DEVELOPMENT REVIEW COMMITTEE

1. BDS Commercial Site Plan

BDS COMMERCIAL SITE PLAN

FINAL PLAN SET

OVERALL UTILITY
LAYOUT

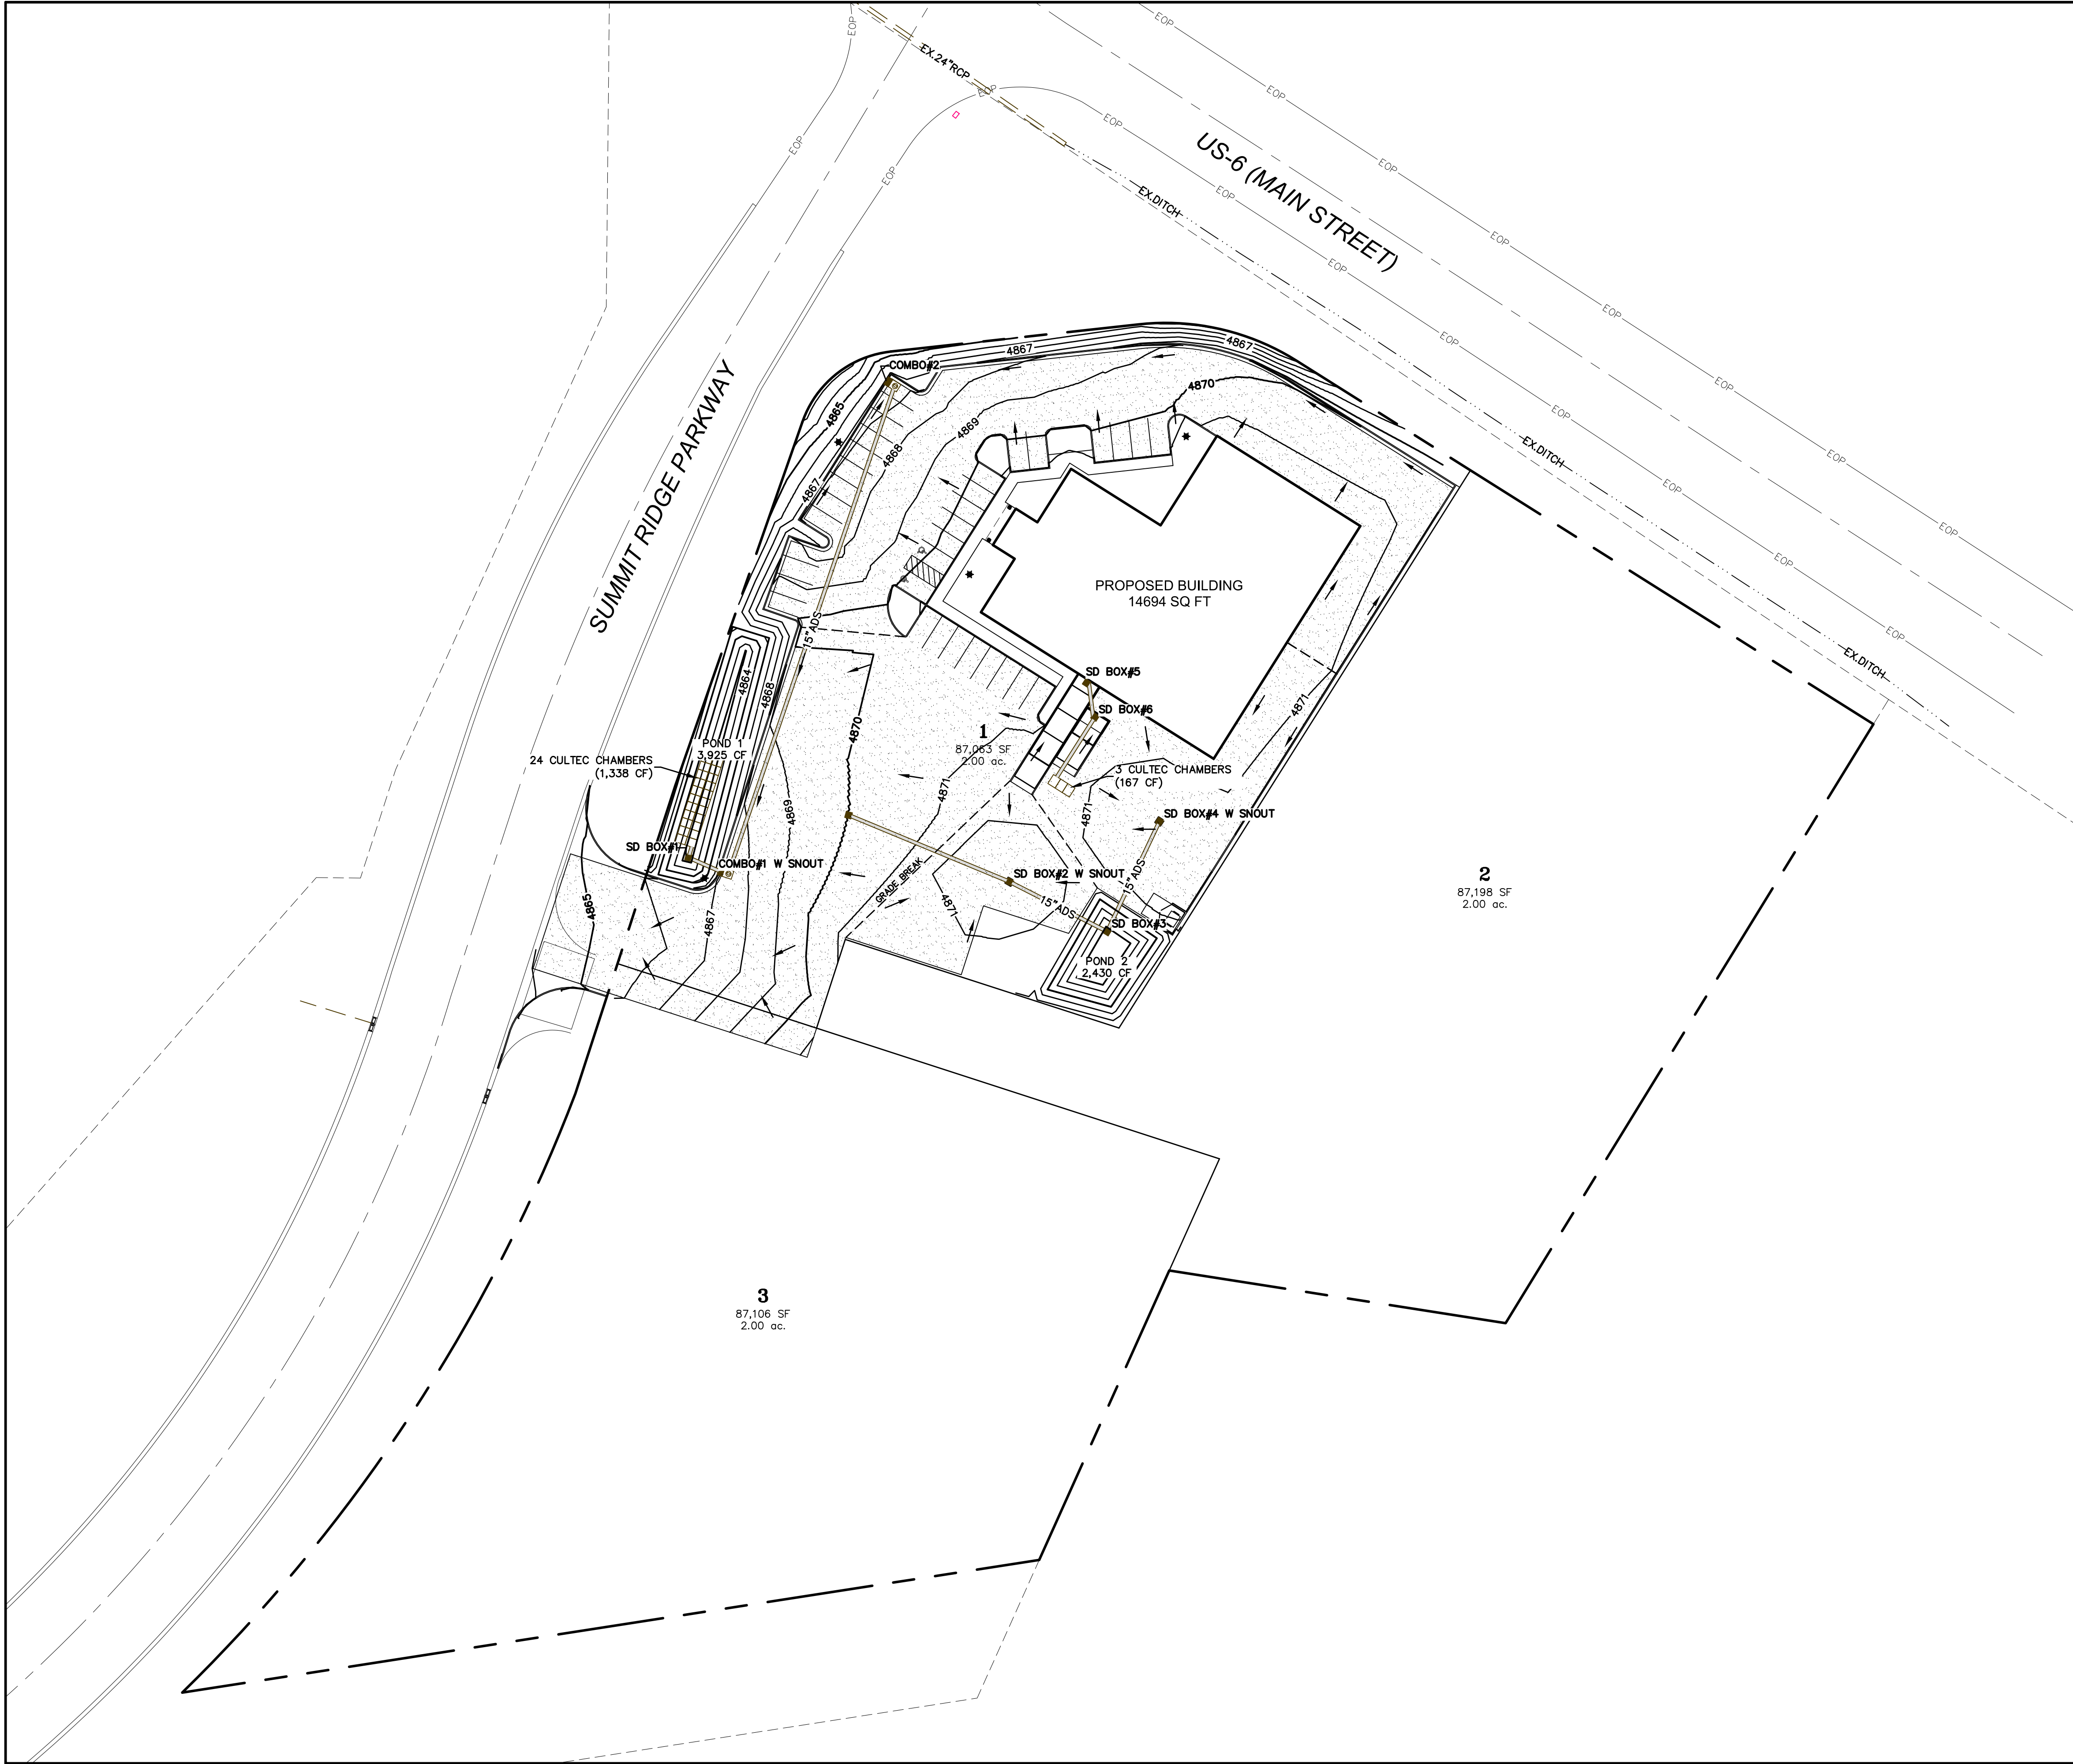
Public Works Director Callaway asked that the applicant call out all water lines and meters on the plans. He confirmed with Engineer Lundell that the City has plans to build a sewer line to the site in the future. He added that all culinary water lines must have a minimum of 10-feet of clearance from any sanitary sewer line. Director Callaway discussed the locations of the meter boxes, pointing out that it's not ideal to have them attached to the building as most leaks occur in the meter boxes. Manager Beagley recommended that a corp stop be placed on both the culinary and PI water laterals. Additionally, the poly pipe from the saddle to the meter must be a continuous line. No joints will be allowed.

Fire Chief Lind pointed out that fire hydrants are missing from the plans. He explained where multiple hydrants need to be placed on the site as well as the need to install a sprinkling system to the building itself. Chief Lind also added that a dedicated fire line needs to be installed at the site to facilitate a Fire Department Connection (FDC). He asked that hydrants be installed on the northeast side of the building as well as the northwest. Members of the DRC discussed where to have the two hydrants installed and possibly looped at the site.

DRAINAGE PLAN

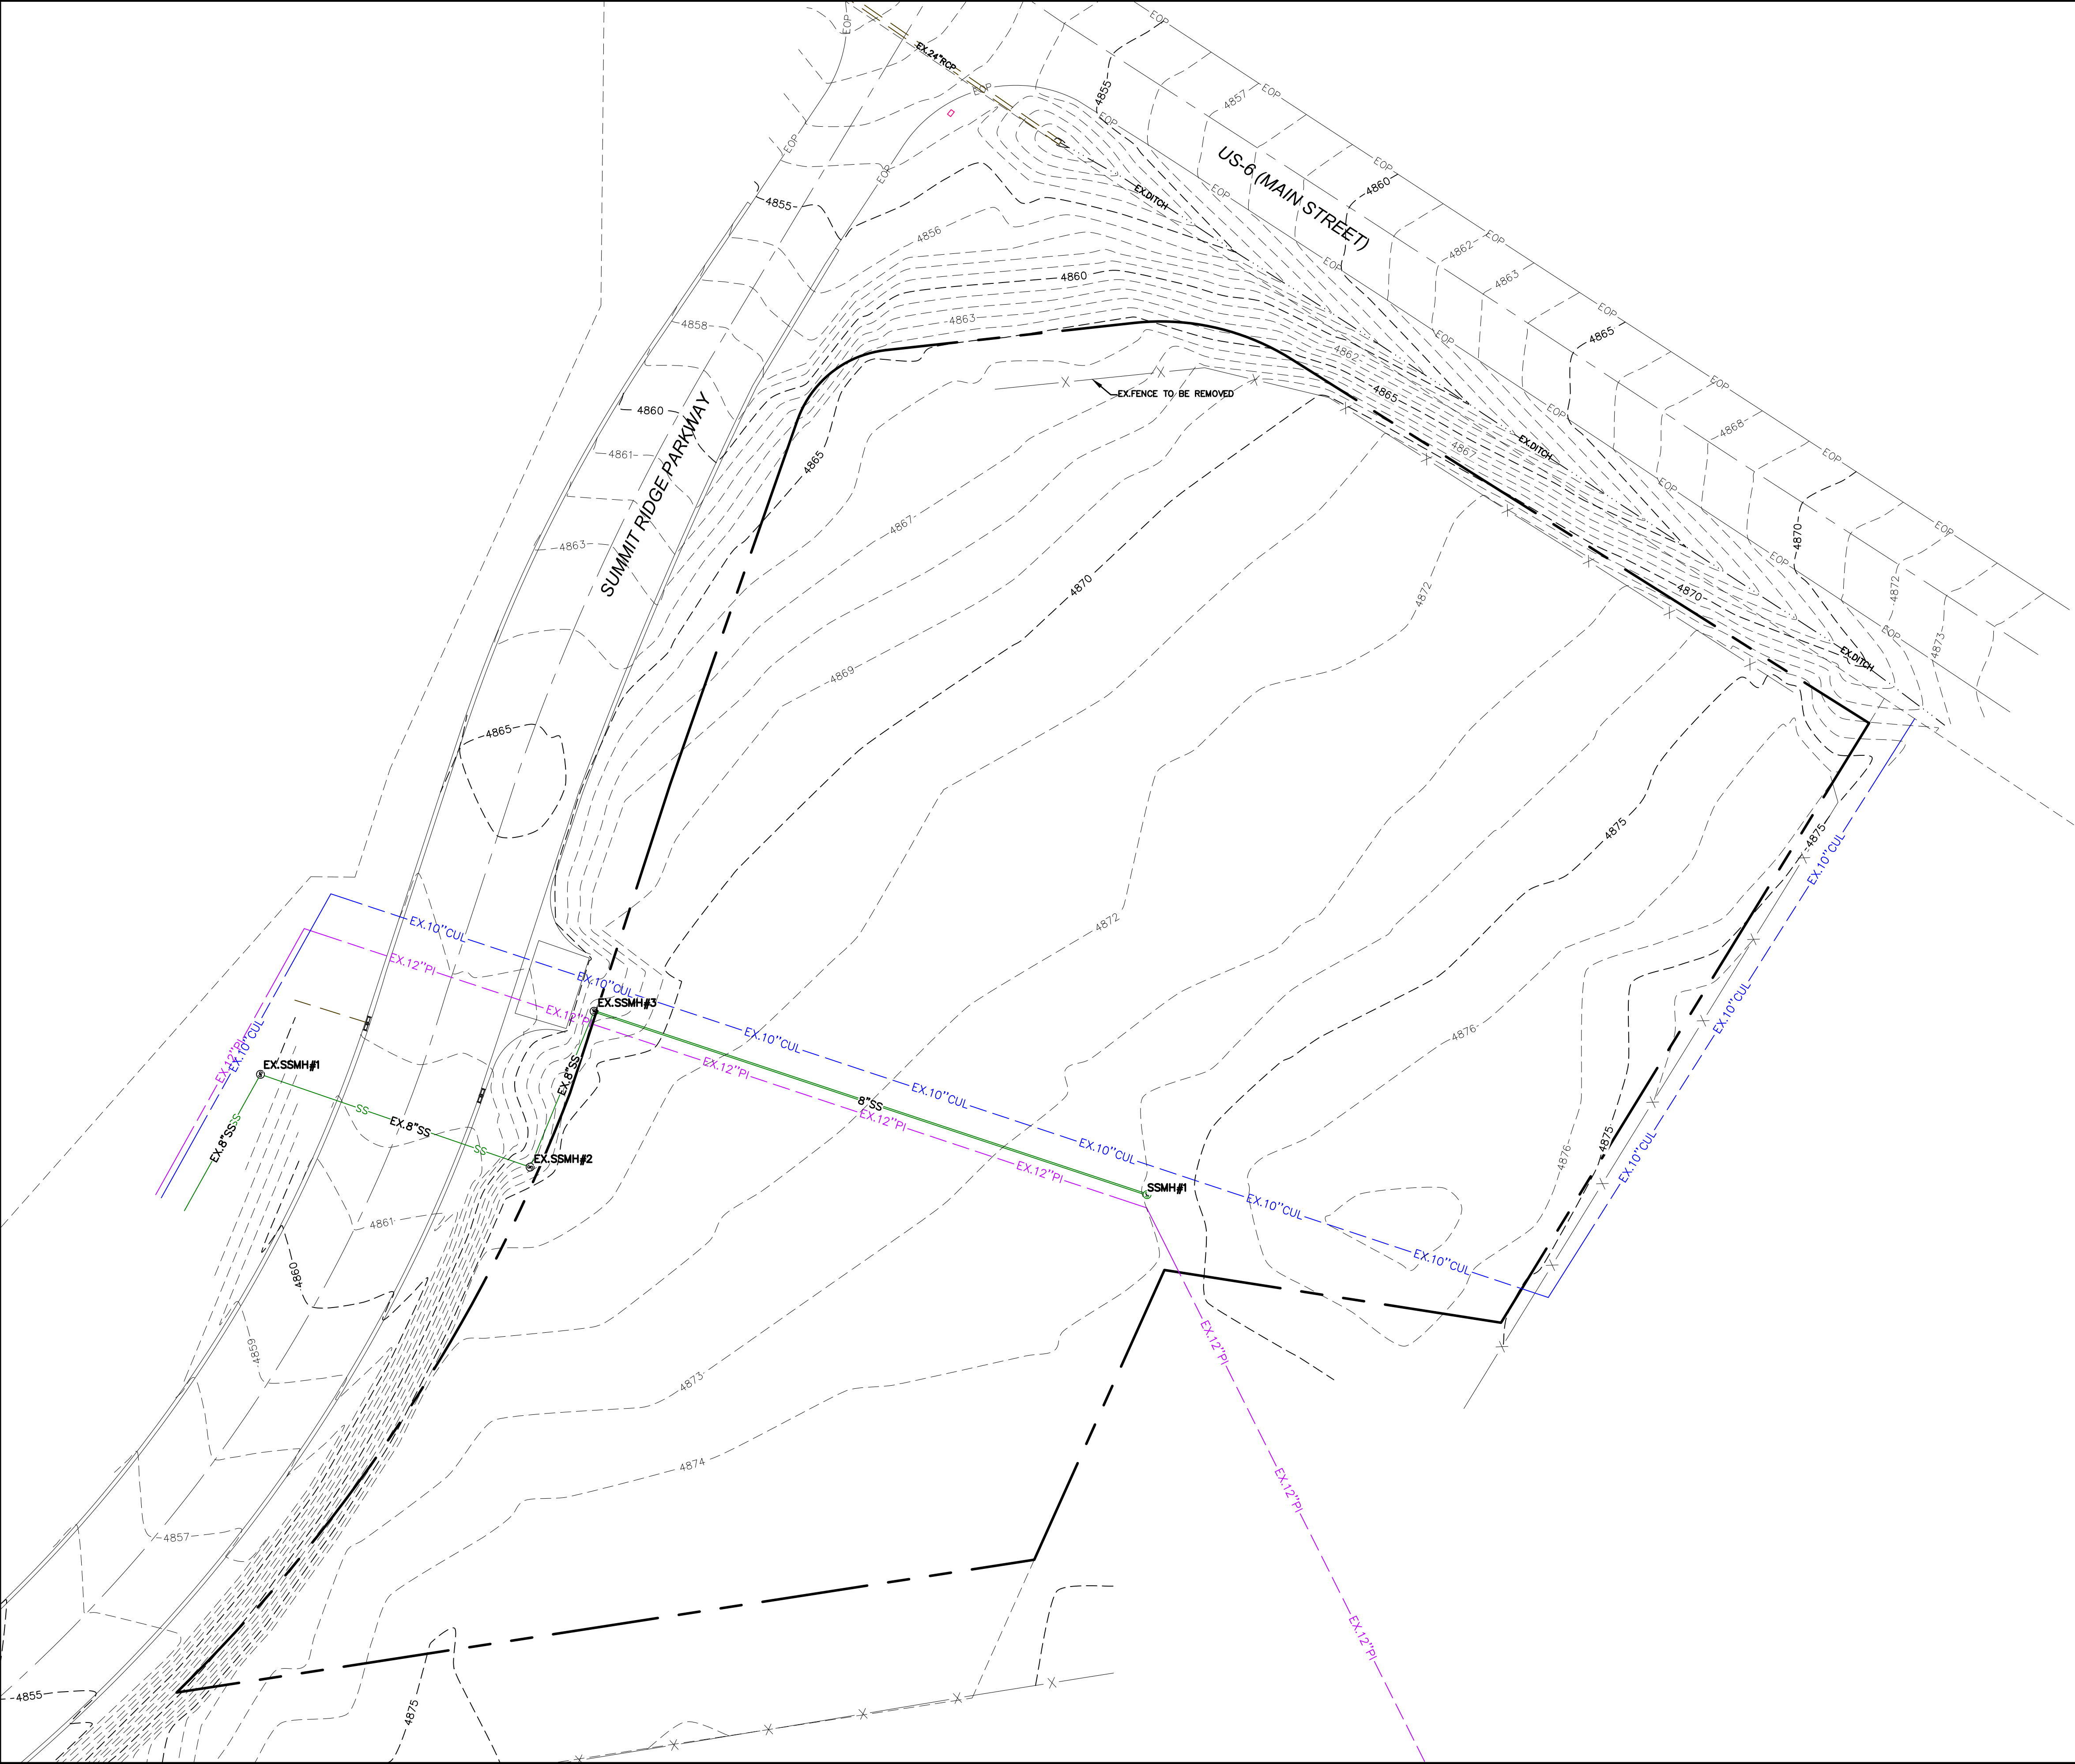
Engineer Lundell and Manager Beagley discussed the requirements for site lighting. The applicant will need to submit a photometric plan for lighting to the City for review. Pedestrian circulation around the building will need to be adjusted to meet the 6-foot requirement in the City Code. Manager Beagley inquired what the applicant's plan is for storm drainage. The applicant indicated that storm drainage is

accounted for in the grading plan. Engineer Lundell discussed in more detail the plan for the sewer line at the site, stating that plans are moving forward for completion of the needed sewer infrastructure in approximately Spring of 2024. He added that if the applicant anticipates being in the building prior to the sewer being completed, a plan must be in place for temporary sewer maintenance and or a septic system. Manager Beagley discussed possibly installing a temporary septic system to be in place prior to the installation of the sewer line.
